TRANSMITTAL OF THE REVISED OPERABLE UNIT 1 TRANSPORTATION AND DISPOSAL PLAN UPDATE; ADDITIONAL LOADOUT FACILITY FOR SP-7, WASTE PITS REMEDIAL ACTION PROJECT, FERNALD CLOSURE PROJECT

SP-7 Implementation Plan

SP-7 Implementation Plan Comments

SK NO.
SK-LSA-1-02

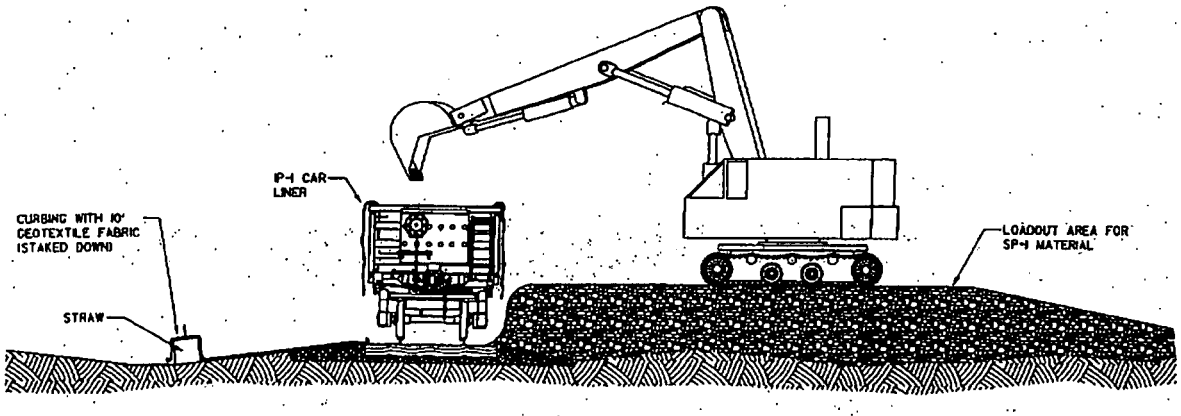
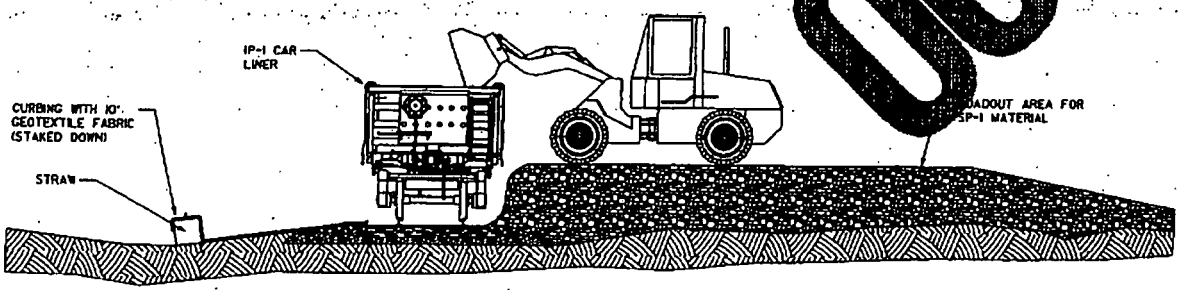
5. Commenting Organization: Ohio EPA Commentor: OFFO
Section #: General Pg. #: Line #: Code: C
Comment: Additional loadout details should also address concerns such as waste falling off the rail car or loaded into areas it is not supposed to be and how that waste will be recovered. Criteria to prevent the loading vehicles arm from extending beyond the opposite side of the rail car should be included. Figure SK-LSA-I-02 shows how an excavator arm should not be extending beyond the rail car. The bucket should always be between the opposite wall of the rail car and the tracks of the loader. Not extending out where waste can fall off into the unplanned areas.

The drawing that shows excavator arm over other side of car was meant to only

illustrate the piece of equipment we intended to use and was limited in size available to our CAD personnel. Operator will be instructed to go no further then center of car while dumping and use the flexibility of a track excavator to smooth/level out the top to the sides.

Action: Implementation Plan and the drawing will be revised . Track excavator operator will be briefed on procedure.

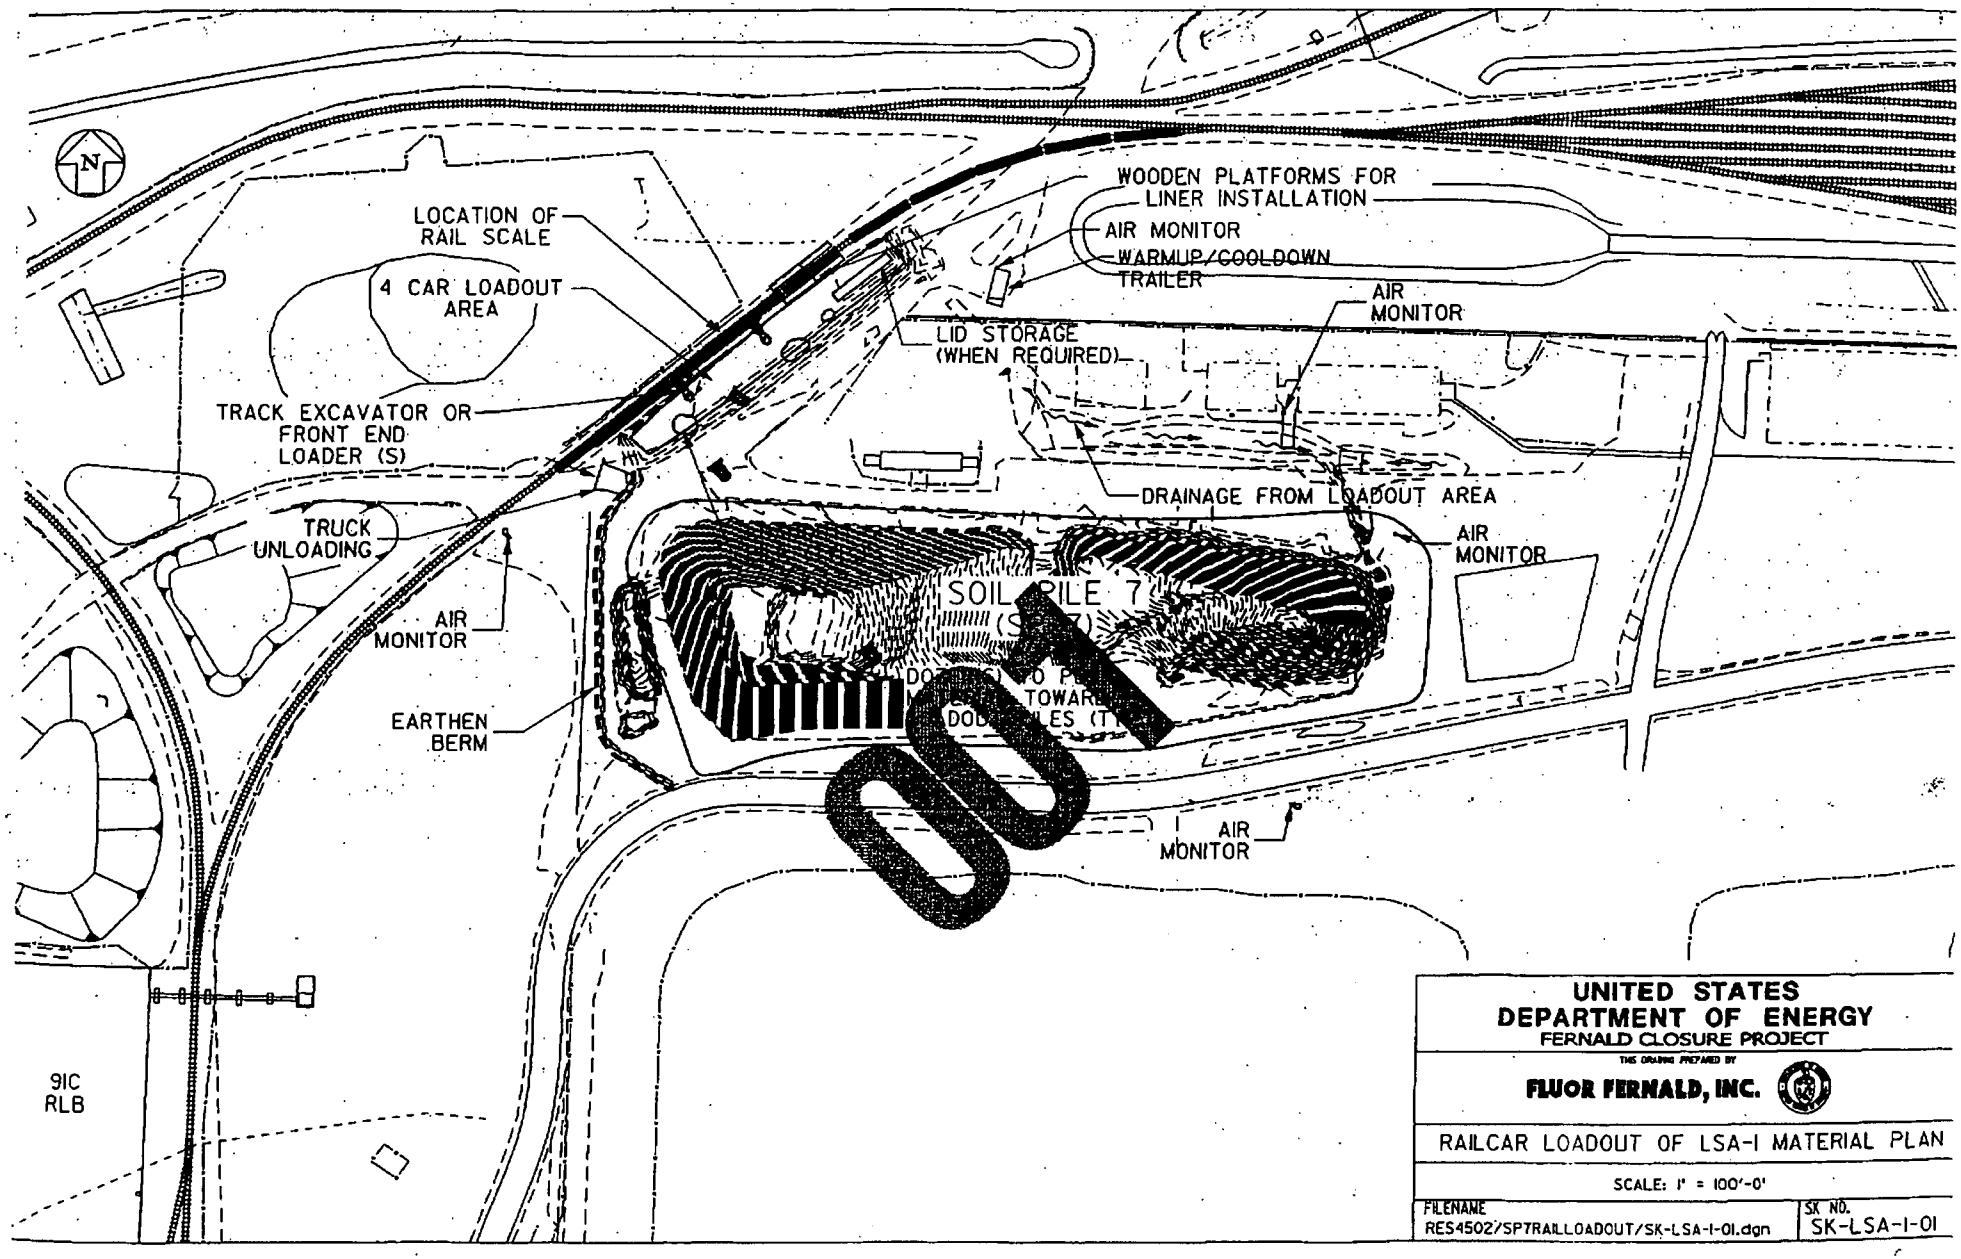
1. Commenting Organization: Ohio EPA Commentor: OFFO
Section #: General Pg. #: Line #: Code: C
Comment: The plan needs to include a detailed contour map showing the proposed completed load out area, silt fence, damn installation and surface water flow paths. This or another figure should detail waste movement pathways: how material is being moved from SP-7 to the load out piles; how that pathway is controlled. The current figue SK-LSA-1-01 suggests dozers will push the soil a minimum of 200' to the load out pile for the furthest rail car. This doesn't appear to be a practical approach.

2. Commenting Organization: Ohio EPA Commentor: OFFO
Section #: General Pg. #: Line #: Code: C
Comment: The original NESHAPs evaluation for Waste Pits Project did not include the simultaneous load out of OU1 materials and SP-7 materials. Provide a NESHAPs evaluation including the new materials to ensure that air monitoring continues to be adequate.

10. Commenting Organization: Ohio EPA Commentor: OFFO
Section #: 3.1.3 Pg. #: Line #: Code: C
Comment:The text lacks in details. See comments 1 above and comments below. Locations of the dams on the north and south ends of the loadout area should be indicated. Placement of the pump used to convey storm water from the west side of the tracks to the east side should be shown. Will any grading be necessary to direct the storm water to a sump? How will the piping be routed around or under the tracks?

the tracks and then to the storm water system.
1) Where will the rainwater that normally flows in the trench drain after the dams are installed?
2) What is the capacity in the trench between the two dams? How much rainfall will the trench safely hold? Provide a map which shows all drainage in the area including the flows in the RR trench up-gradient of this Project.

Response: In the meeting, it was agreed that a contour map is not necessary. However, a drawing will be generated to show the layout and features around the SP-7 requested by OEPA. Fluor understands that pushing soil distances of 200' is not the most efficient. Fluor intends to keep heavy equipment usage in the SP7 area to a minimum and since the area is rough and not prepared for truck traffic it is better to use dozers.

Action: Fluor to survey expanded SP7 load out area and generate as built drawing depicting the features requesed by EPA.

Action: Map will be modified to show location of air monitors.

Action: Update drawing to as built condition.
